UNITED STATES PATENT AND TRADEMARK OFFICE

APPLICATION NO.	FILING DATE	FIRST NAMED INVENTOR	ATTORNEY DOCKET NO.	CONFIRMATION NO.
09/970,294	10/02/2001	Gary K. Michelson	101.0070-02000	2538
22882	7590	10/14/2003		
MARTIN & FERRARO, LLP 1557 LAKE O'PINES STREET, NE HARTVILLE, OH 44632				
			EXAMINER PRIDDY, MICHAEL B	
			ART UNIT 3732	PAPER NUMBER

Office Action Summary

DETAILED ACTION

FIGURE 1A

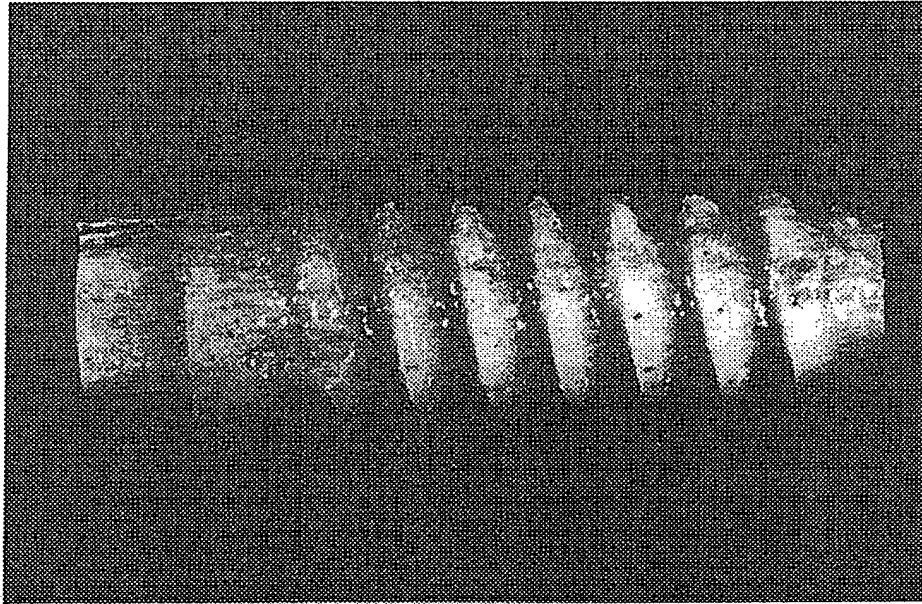
Claims 91, 93-95, 97, 109, 110, 115, 119, 121-123, 130 and 131 are rejected under 35 U.S.C. 103(a) as being unpatentable over Grooms et al. (U.S. 6,045,554) in view of Greenslade (U.S. 5,088,869). Grooms et al. teaches a screw formed of cortical bone for use in the human body (see Exhibit A), said screw comprising a leading end, a trailing end opposite said leading end, and a shaft therebetween, said shaft having a mid-longitudinal axis, a length and a thread extending from said shaft along at least a portion of its length; said thread configured to cooperatively engage at least a portion of the screw hole of an implant so as to prevent said screw from linear motion along the mid-longitudinal axis of said shaft in a direction opposite to the direction of insertion when said screw is threaded through a screw hole to attach the implant to a bone portion of the human body; said screw being formed substantially of cortical bone of a single thickness ("cortical sections are removed from linear aspects of the femur or from the anterior cortex of the tibia"-- column 4, lines 25&26). As set forth in lines 34-36 of column 3, "the head may have a machined, recessed Allen-wrench, star headed driver, Phillips head or slotted head purchase for torque application."
